DEVELOPMENT REVIEW BOARD MEETING
APRIL 10, 2023
6:30 PM

2. **Resolution No. 413. Precision Countertops Project.** The applicant is requesting approval of a Stage 1 Preliminary Plan, Stage 2 Final Plan, Site Design Review, Waiver, Class 3 Sign Permit, and Type C Tree Removal Plan for development of a 66,000 square foot corporate headquarters and fabrication facility on property located at 25540 SW Garden Acres Road.

Exhibit A1
Staff Report
Wilsonville Planning Division
Precision Countertops
Development Review Board Panel 'A'
Quasi-Judicial Public Hearing

Hearing Date:	April 10, 2023
Date of Report:	April 3, 2023
Application No.:	DB22-0011 Precision Countertops
Request/Summary:	The requests before the Development Review Board include a Stage 1 Preliminary Plan, Stage 2 Final Plan, Site Design Review, Waiver, Class 3 Sign Permit, and Type C Tree Removal Plan.
Location:	25540 SW Garden Acres Road. The property is specifically known as Tax Lot 500, Section 2C, Township 3 South, Range 1 West, Willamette Meridian, Washington County, Oregon
Owner/Applicant:	PCT NW Properties OR, LLC, dba Precision Countertops, Inc. (Contact: Robert Hausserman)
Authorized Representative:	MDG Architecture

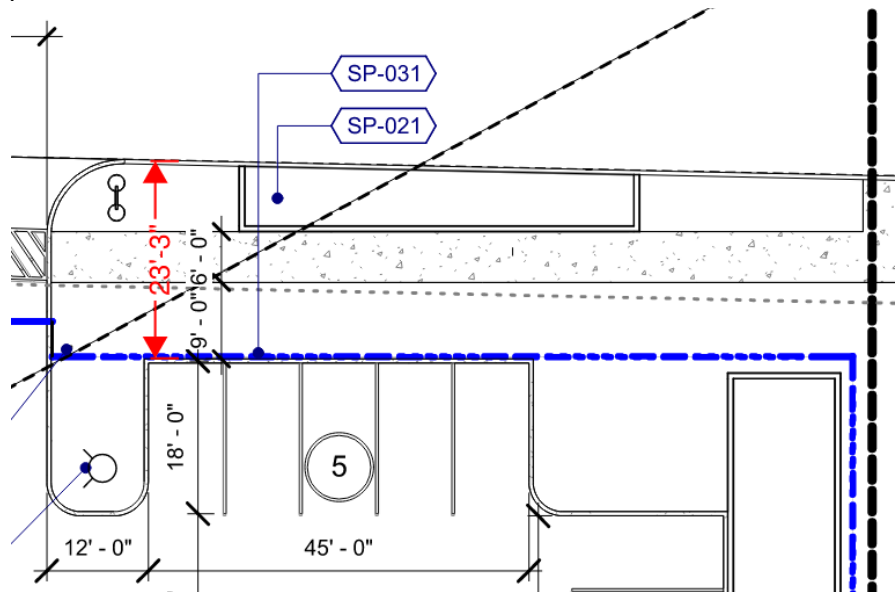
- B. Include a column in the tree survey table on Sheet L1.1 that indicates for each tree whether it will be removed or retained.

Response: Sheet L1.1 includes the Tree Inventory Table from the Arborist Tree Survey. The table now includes a column indicating whether the tree is slated for remove or to be retained.

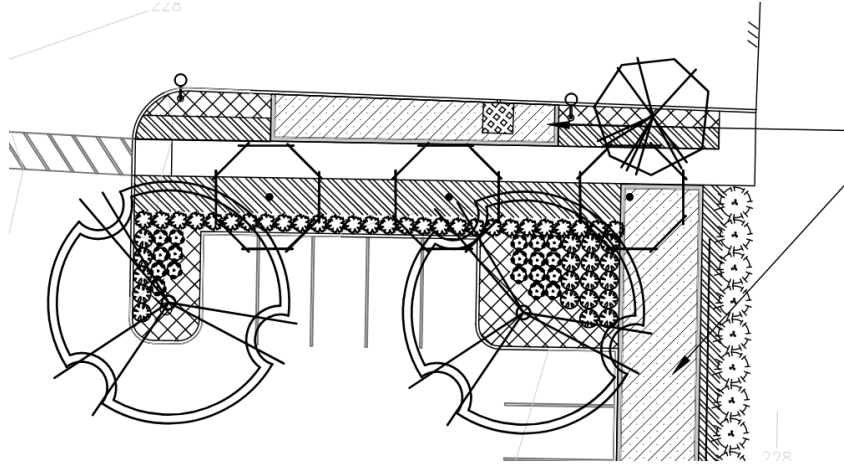
- c. Table CC-3 Site Design, 4. Parking Location and Design, Parking Lot Sidewalks and Parking Perimeter Screening and Landscaping. Demonstrate how the minimum 9-foot depth for planted areas adjacent to off-street parking areas and the General Landscape Standard or Low Berm Standard (see Section 4.176 (.02) C. and F.) are met for the east parking area on the Supporting Street. There doesn't appear to be any landscaping to screen parking from the Supporting Street in this area, as the sidewalk is curb-tight to the parking.

Response: The proposed development includes a 9ft landscaped planted area adjacent to the northeast parking area on the

Supporting Street. Dimension has been added to A1.1 noting the depth of landscaped area. The following exhibit shows that all General Landscaping standard have been met.

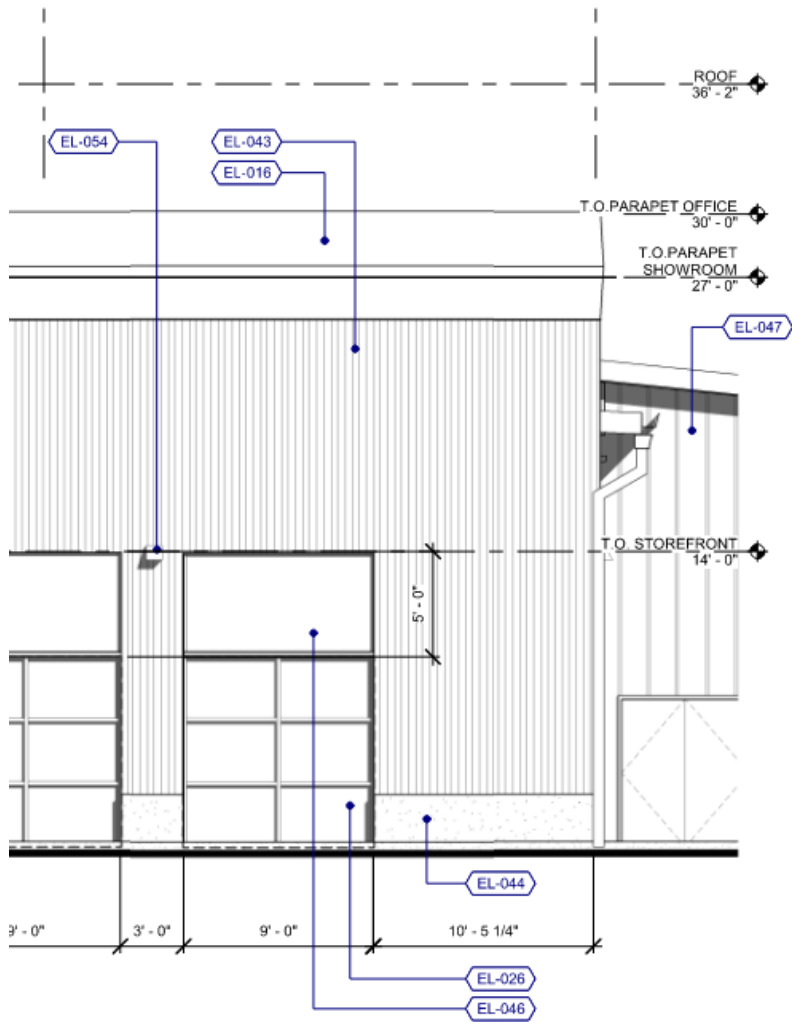
- d. Table CC-3 Site Design, 5. Grading and Retaining Walls, Maximum Height, Required Materials, Retaining Wall Design. Demonstrate how the standards are met for the retaining wall along the Supporting Street shown on Sheet C3.0.

Response: *The proposed development has been revised, removing all retaining walls along the Supporting Street. Requirement no longer applied.*

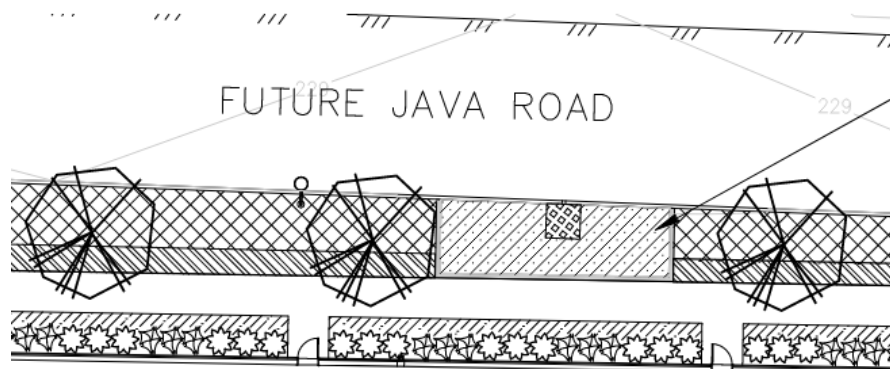
E. Correct inconsistencies in the plans with respect to sidewalk placement on the north elevation of the building along the Supporting Street. While the majority of plans show the sidewalk immediately adjacent to the building with no landscape separation, the Fire Service Site Plan (Sheet FS1.0), Lighting Plans (Sheets LT1.0 and LT1.2), and Recycling Flow &

Details (Sheet G3.0) all show a landscape area between the building and sidewalk.

Response: *The Sheets FS1.0, LT1.0, LT1.2, G3.0 have been updated and are consistent with respects to all design elements, including sidewalk placement, setbacks, building floor plan, dimensions, access, etc.*

TREE REMOVAL AND PROTECTION PLAN

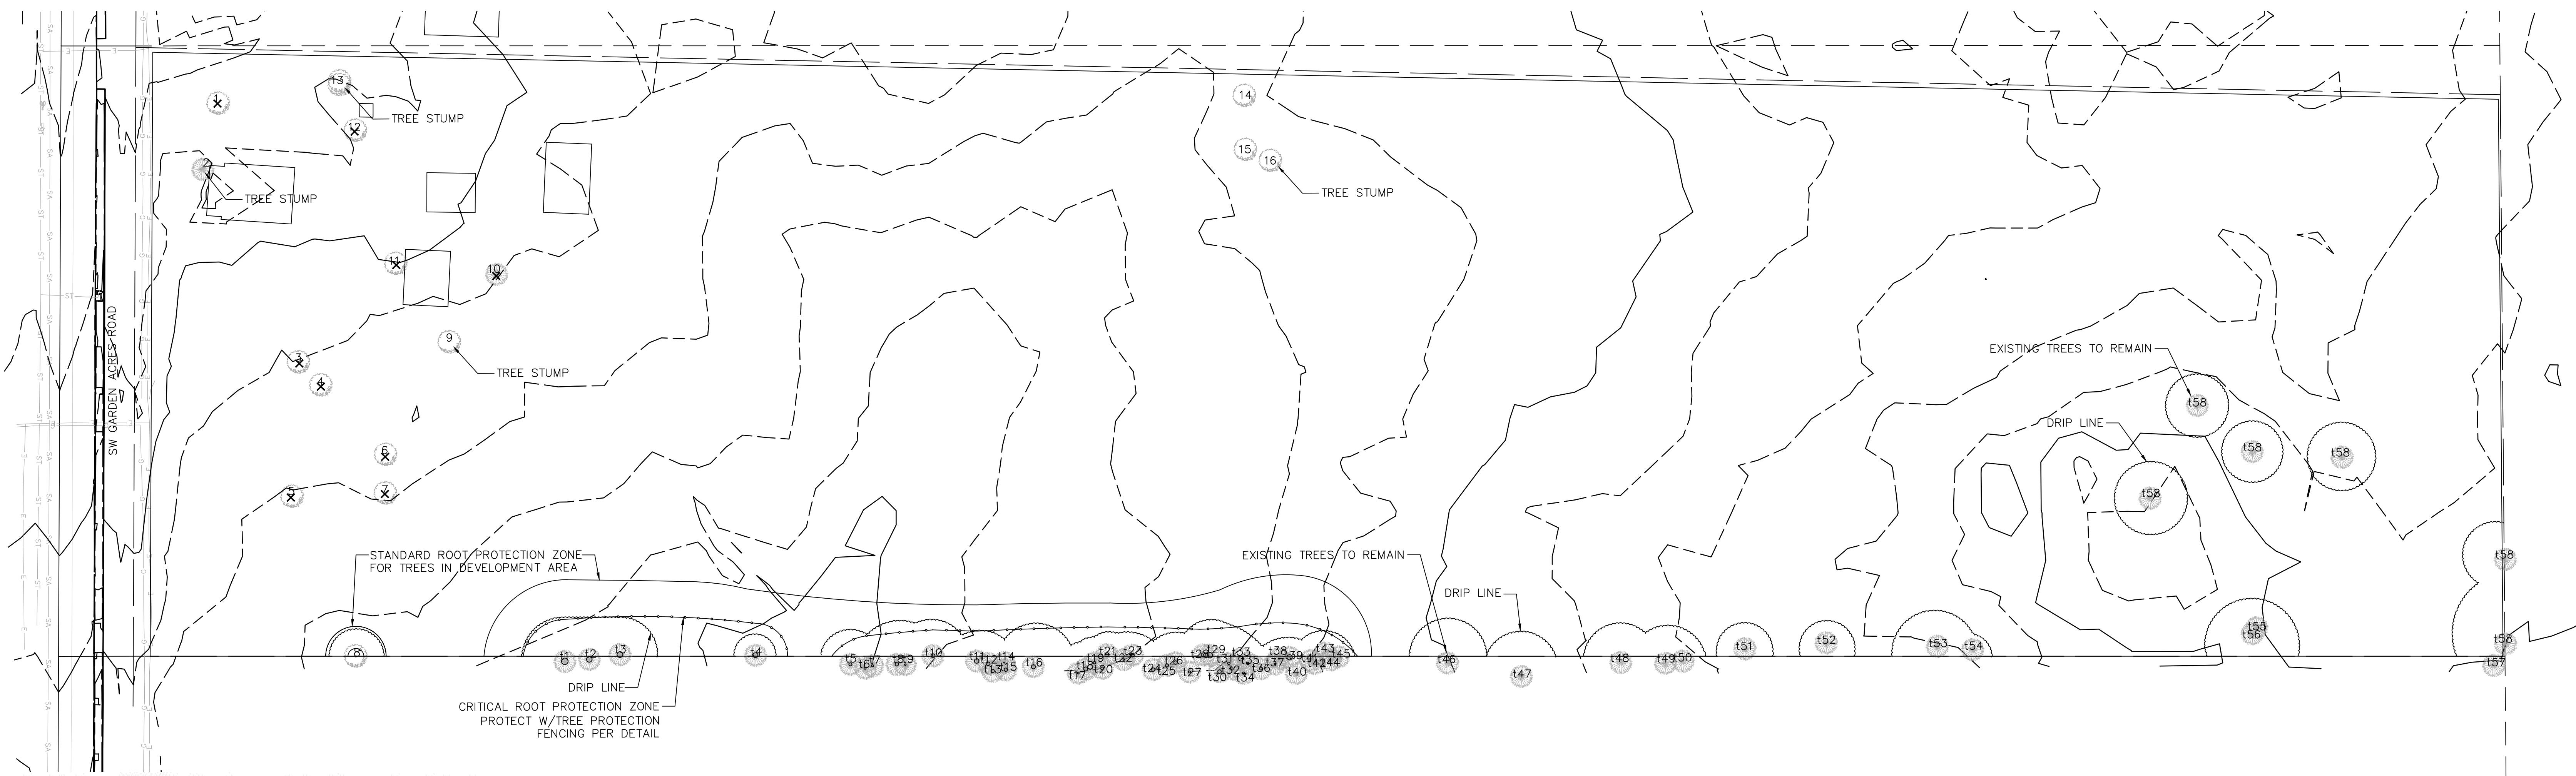
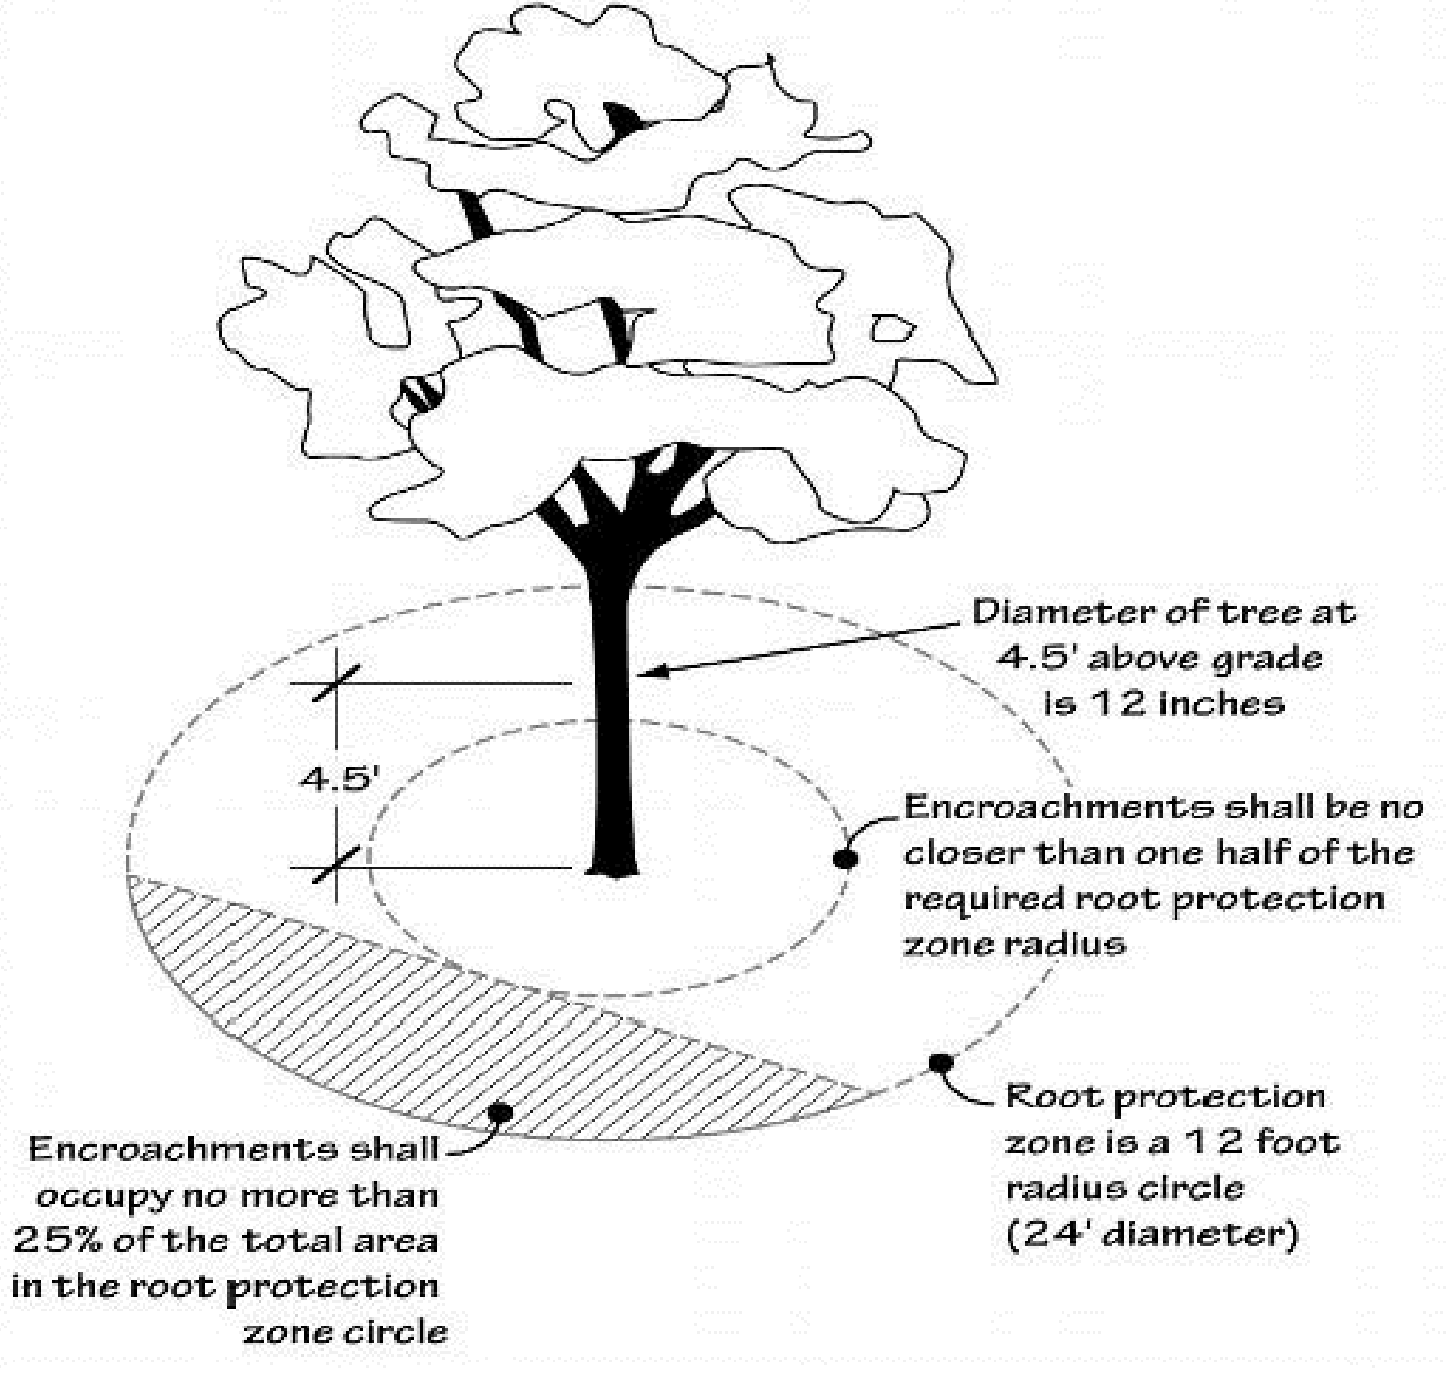
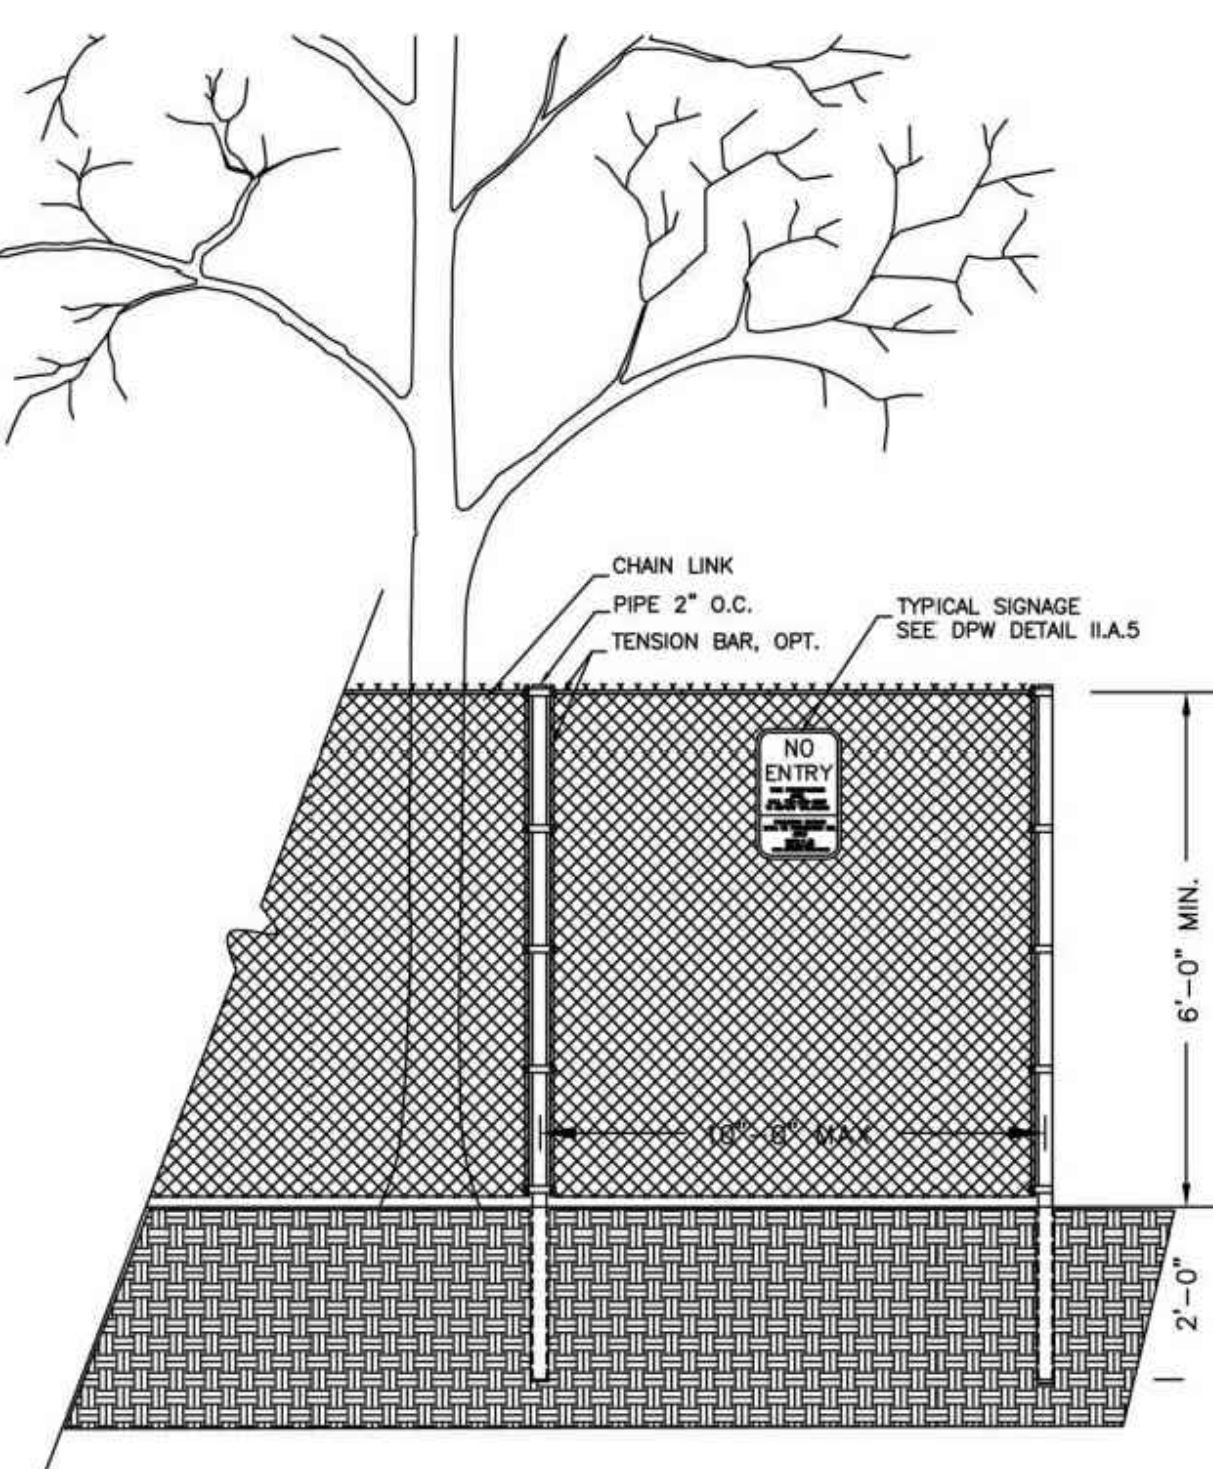
F7. The applicant has submitted the necessary copies of a Tree Maintenance and Protection Plan. See the applicant's Sheet L1.1 in Exhibit B2.

Response: *The landscape plan (L1.1) has been updated to illustrate the existing trees from the survey and trees to remain.*
